ECE/TRANS/WP.29/2008/81
23 July 2008

World Forum for Harmonization of Vehicle Regulations

Proposal for Supplement 7 to Regulation No. 13-H
(Brakes of M₁ and N₁ vehicles)

Submitted by the Working Party on Brakes and Running Gear (GRRF) */

Figure 1 Steering wheel position and yaw velocity information used to assess lateral stability.

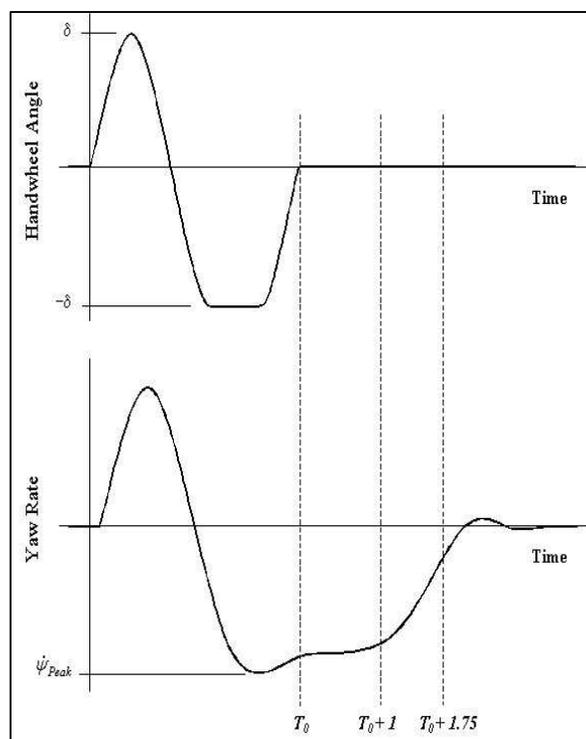
- 3.1. The yaw rate measured 1 second after completion of the Sine with Dwell steering input (time $T_0 + 1$ in Figure 1) shall not exceed 35 percent of the first peak value of yaw rate recorded after the steering wheel angle changes sign (between first and second peaks) ($\dot{\psi}_{Peak}$ in Figure 1) during the same test run.

- 3.2. The yaw rate measured 1.75 seconds after completion of the Sine with Dwell steering input shall not exceed 20 percent of the first peak value of yaw rate recorded after the steering wheel angle changes sign (between first and second peaks) during the same test run.
- 3.3. The lateral displacement of the vehicle centre of gravity with respect to its initial straight path shall be at least 1.83 m for vehicles with a GVM of 3,500 kg or less, and 1.52 m for vehicles with a maximum mass greater than 3,500 kg when computed 1.07 seconds after the Beginning of Steer (BOS). BOS is defined in paragraph 5.11.6.
- 3.3.1. The computation of lateral displacement is performed using double integration with respect to time of the measurement of lateral acceleration at the vehicle centre of gravity, as expressed by the formula:

Figure 2 Sine with Dwell

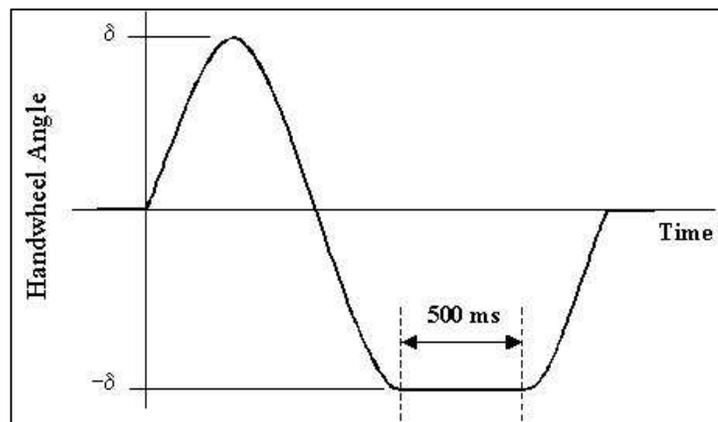
The vehicle is subjected to two series of test runs using a steering pattern of a sine wave at 0.7 Hz frequency with a 500 ms delay beginning at the second peak amplitude as shown in Figure 2 (the Sine with Dwell tests). One series uses anticlockwise steering for the first half cycle, and the other series uses clockwise steering for the first half cycle. The vehicle is allowed to cool-down between each test runs for a period of 1.5 to 5 minutes, with the vehicle stationary.

- 5.9.1. The steering motion is initiated with the vehicle coasting in high gear at 80 ± 2 km/h.
- 5.9.2. The steering amplitude for the initial run of each series is 1.5 A, where A is the steering wheel angle determined in paragraph 5.6.1.

- 5.9.3. In each series of test runs, the steering amplitude is increased from run to run, by 0.5 A, provided that no such run will result in a steering amplitude greater than that of the final run specified in paragraph 5.9.4.

- 5.9.4. The steering amplitude of the final run in each series is the greater of 6.5 A or 270 degrees, provided the calculated magnitude of 6.5 A is less than or equal to 300 degrees. If any 0.5 A increment, up to 6.5 A, is greater than 300 degrees, the steering amplitude of the final run shall be 300 degrees.
